Engineering Division  
W/OSO321:FJZ

M003 MODIFICATION NOTE 4  
(for Electronics Technicians)

SUBJECT : SPU 11 Vaisala Sounding Processor Board installation

PURPOSE : Modify the present M003 configuration to be compatible with the new Vaisala radiosondes

Figure 2

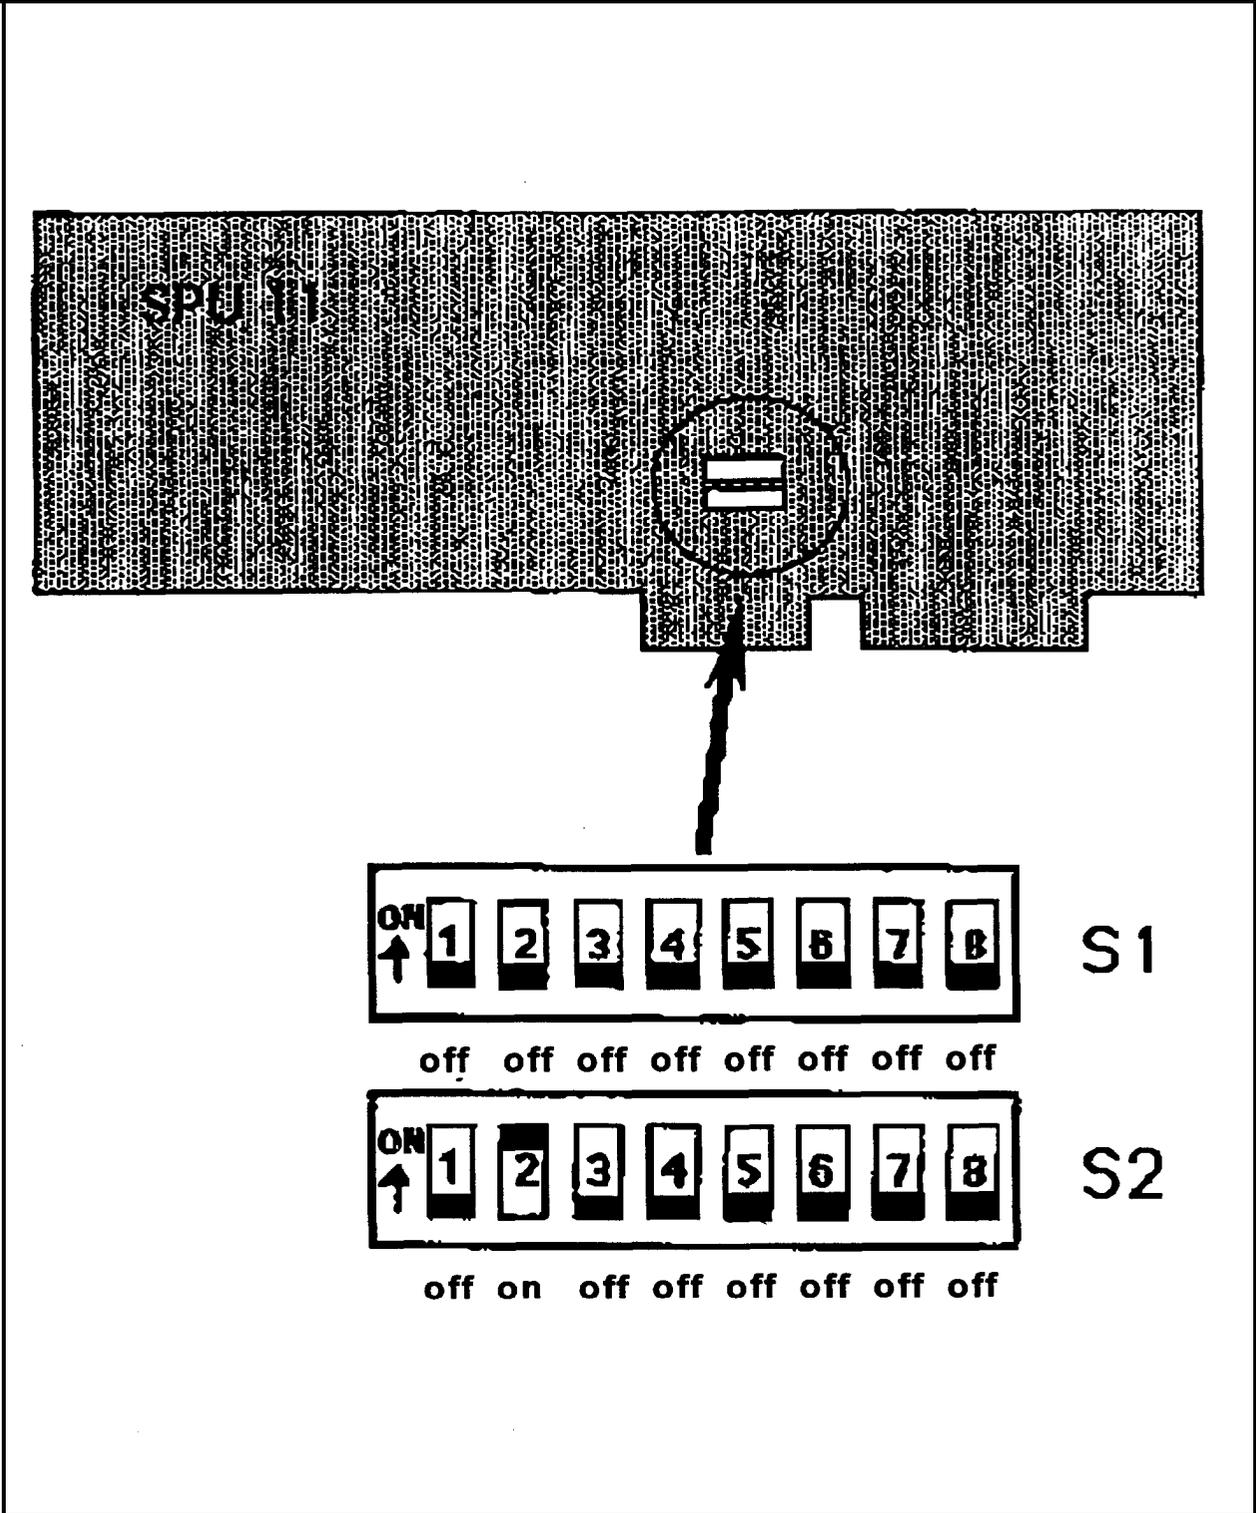
5. Before installing the SPU 11, set the DIP switch settings as shown in Figure 2.
6. Remove the W37A cable from the back of the ARTIC card.
7. Locate slot 4.

SOLUTION 2: Verify proper switch settings of SW1 and SW2 on the SPU 11 card.

Figure 3

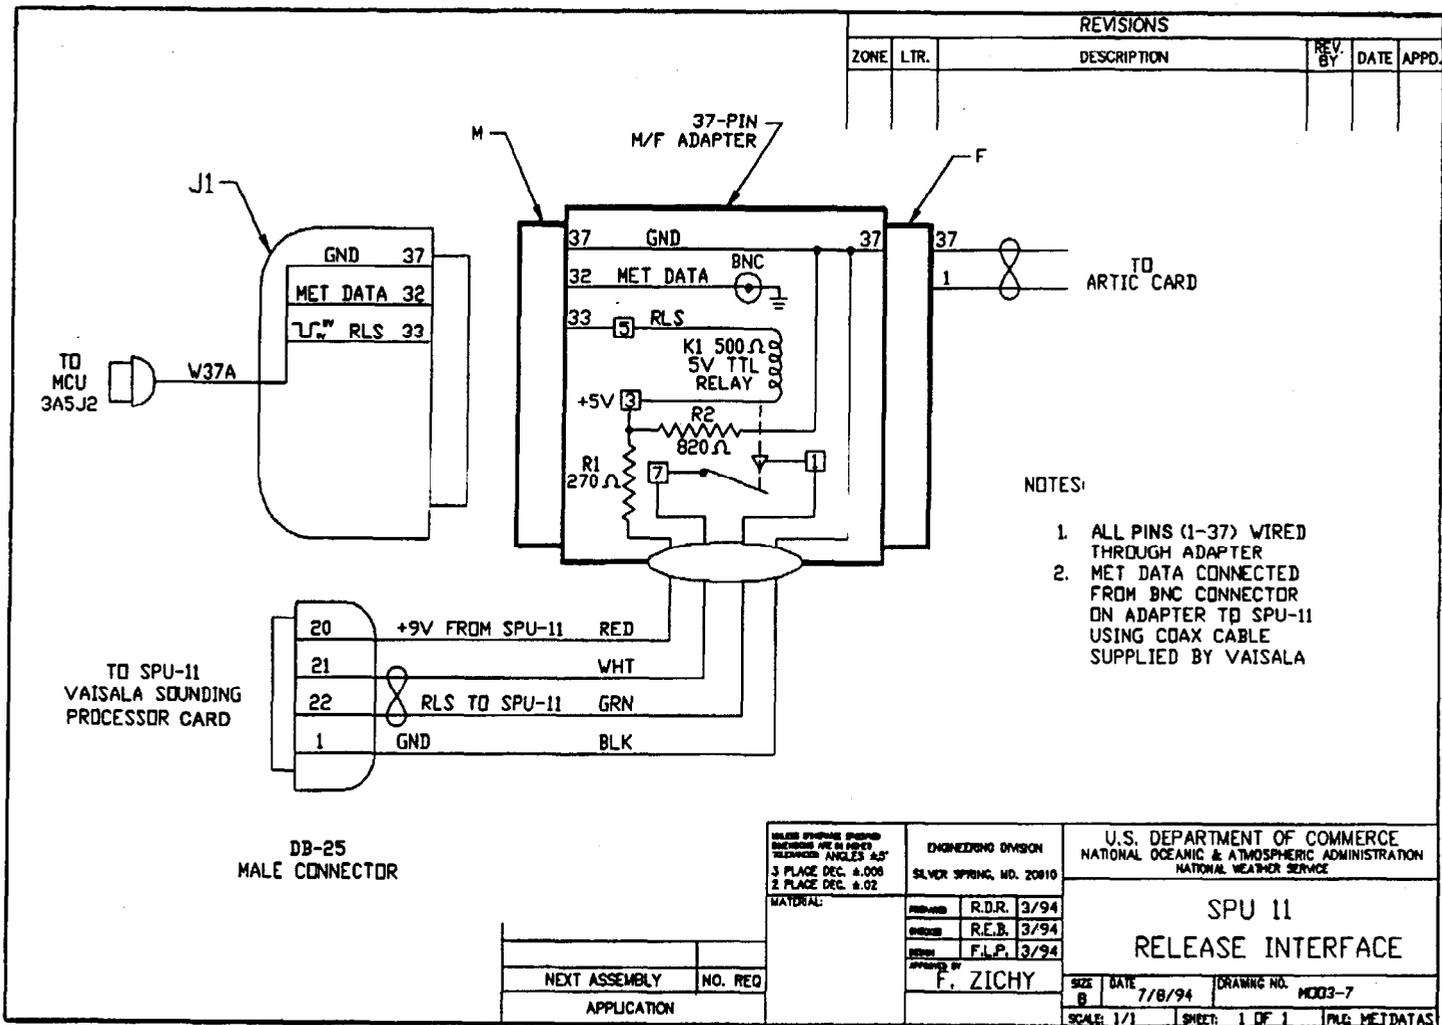
SOLUTION 4: Disconnect the DB-25 male connector of the release interface from the back of the SPU 11 card. Depress the MANUAL RELEASE push button and with an ohmmeter, verify a short between pins 21 and 22 (Figure 3). If a short is not present, replace the release interface connector.
